IMPORTANT SAFETY RECALL – SN606

Safety Recall Notice 13V-160

SN-606-13

SUBJECT: Platform leveling arm

Clean and inspect
this area of arm

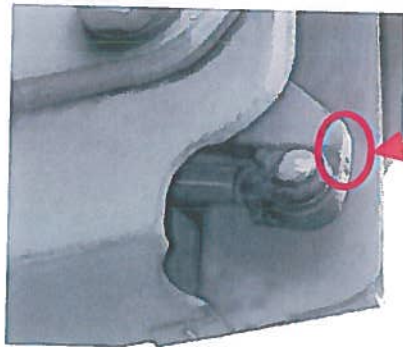
Terex Utilities has received notifications that a structural fatigue crack has been found in some older OM series leveling arms built from 1998 to 2005. The leveling arm keeps the platform level during operation. **Failure of the level arm may result in unintended platform tilting, collision, and occupants falling from the platform.**

This safety notice requires the inspection of the leveling arm, at the elbow, for any cracks specifically in the area indicated below.

1. Clean the area around the grease zerk on each side and visually inspect for cracks. If required use an approved NDT inspection method such as dye penetrant.
2. If a crack is found: Contact Terex Utilities, at the phone number or email shown below and provide the aerial serial number and your contact information to arrange repairs. Remove the machine from service until repairs are completed.
3. If no crack is detected: Contact Terex Utilities; through your nearest TEREX Utilities dealer as shown on the web site, terexutilities.com, call Terex Utilities at 605-884-3892 or by email at utilities.warranty@terex.com to arrange for repair within 30 days of receiving this bulletin.

Machines affected by this safety notice may remain in service provided the leveling arm is inspected, for cracks, before and after each working shift until this safety notice is completed.

Dealers and Installers: A letter is being sent to owners of affected units. If affected units are in your area TEREX Utilities will contact you to arrange the repairs. Field Service kit Z1264 will be provided to the nearest Terex Utilities dealer or Field Service Technician for installation.
